CITY OF ALBUQUERQUE

RE: 6004 Sierra Linda Ave. NW Grading and Drainage Plan Engineers Stamp Date 3/18/2024 (E11D032)

Albuquerque, NM 87123 GRADING AND DRAINAGE PLAN

LOT 11, BLOCK 6 **VOLCANO CLIFFS** RESIDENTIAL 6004 SIERRA LINDA AVENUE NORTHWEST ALBUQUERQUE, NM 87120 SHEET 1 OF 1

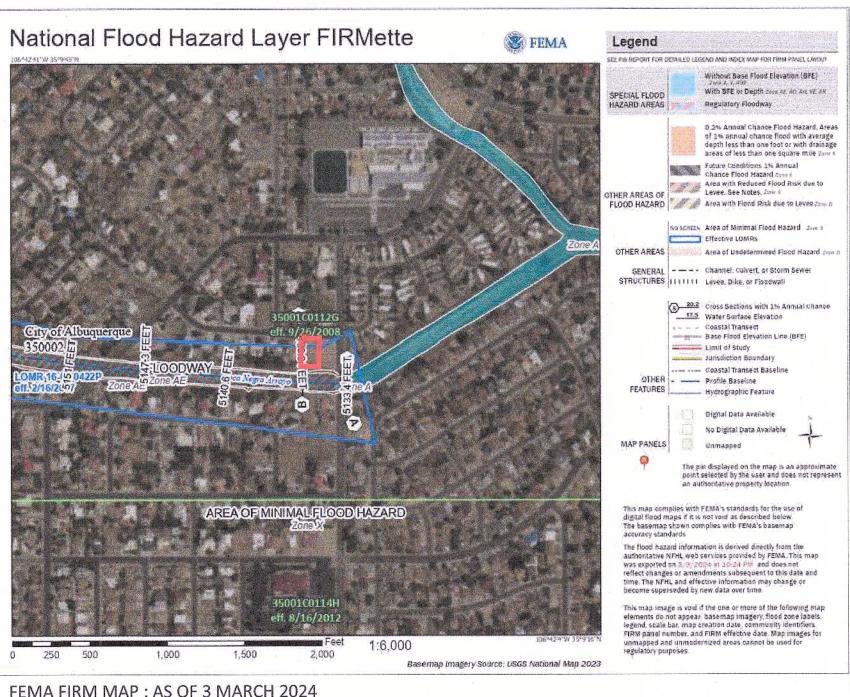
Based upon the information provided in your submittal received 3/19/2024, this plan is approved for Grading Permit.

Prior to Building permit approval a Pad Certification will be required, provided by the Engineer or a registered Land Surveyor.

Advise the owner contractor not to use dirt as a ramp to climb the curb, use lumber or crusher fines for this purpose.

Reiterate to the Owner/Contractor that a separate permit for a garden/retaining wall must be obtained with the approved G&D plan and Pad Certification. Also, if a swimming pool is to be placed the grading and drainage plan will need to be revised and resubmitted to our section.

Prior to Certificate of Occupancy release, Engineer Certification per the DPM checklist is required.
